UNITED STATES PATENT AND TRADEMARK OFFICE

Office Action Summary

10/529,562

DETAILED ACTION

Filed June 10, 1964

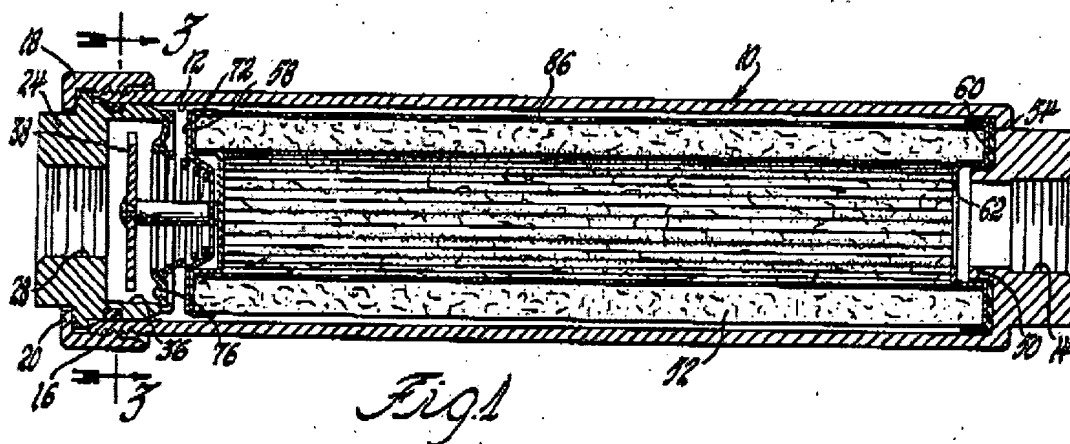
4. Claims 1-2, 4 and 8-9 are rejected under 35 U.S.C. 102(b) as being anticipated by Eddy et al. (U.S. 3,327,858).

Eddy teaches a shut-off device including a connector (figure 2) having an inlet passageway and an inlet connector port 80. A poppet valve body 38 is positioned within a valve chamber of the connector and includes a projecting rod 70 [as in claims 1 and 4]. A filter including a housing defining an inlet port at an end portion thereof and an outlet port 14 at the other end portion

thereof. Upon threaded connection of the filter housing to the connector, cap 58 acts as a pusher to open the valve body 38 to allow liquid to flow into the filter from the inlet 28 [as in claims 2 and 9]. Element 76 is a removable retainer for the valve body [as in claim 8].

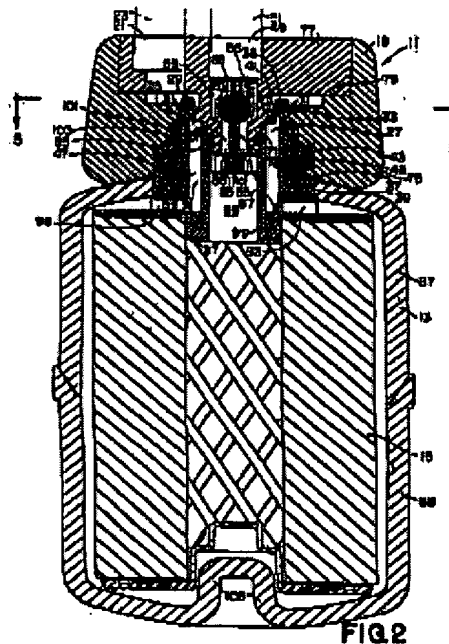
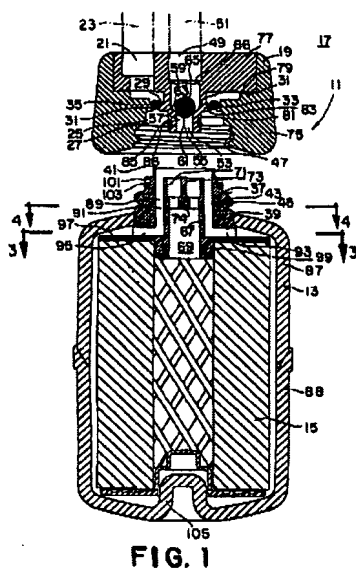
5. Claims 1-3, 6-7 and 9 are rejected under 35 U.S.C. 102(b) as being clearly anticipated by Williams (U.S. 5,695,168).

As can be readily seen in figures 1 and 2 produced above, Williams teaches all the limitations of the aforementioned claims including both the inlet and outlet ports of the connector including a ball valve body that is opened by a respective pusher of the filter. As explained in the 112 rejection above, claim 7 only requires two ports.

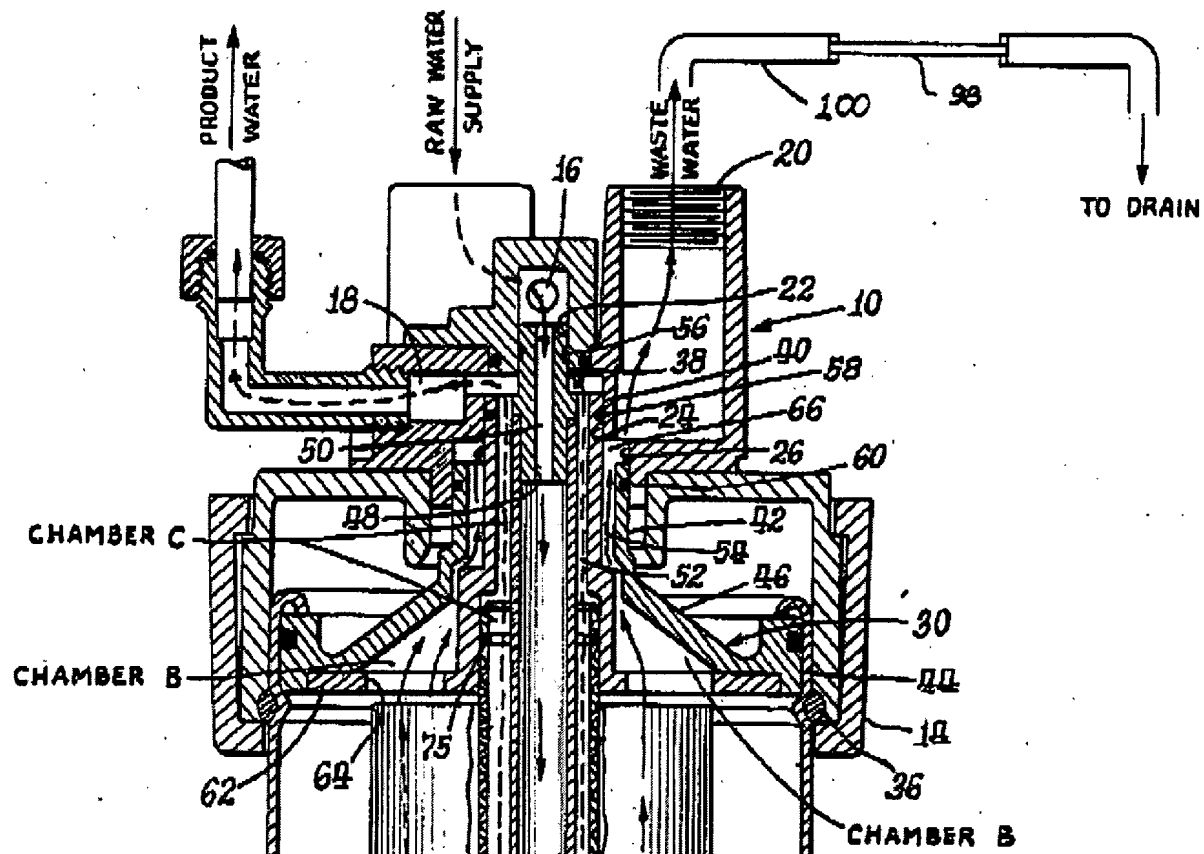
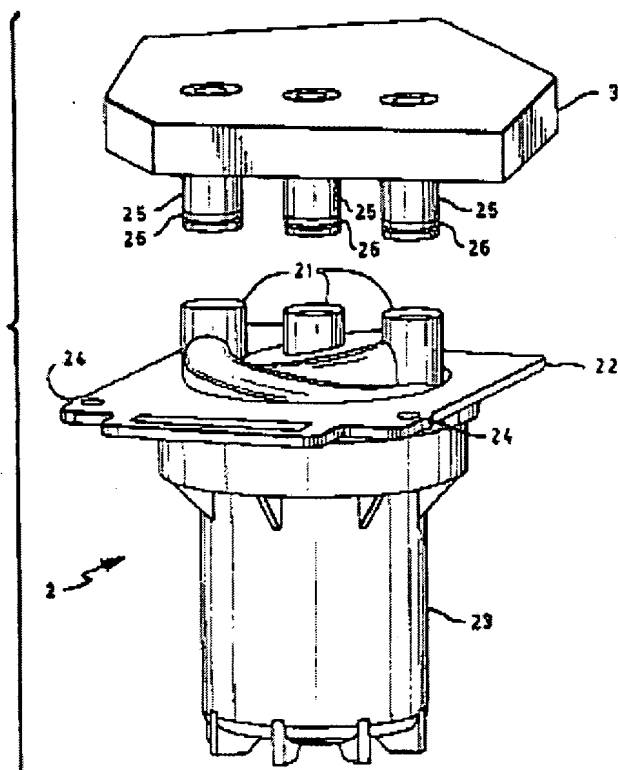
8. Concerning the subject matter of applicant's invention of a connector having three ports, such is known in the art as shown below.
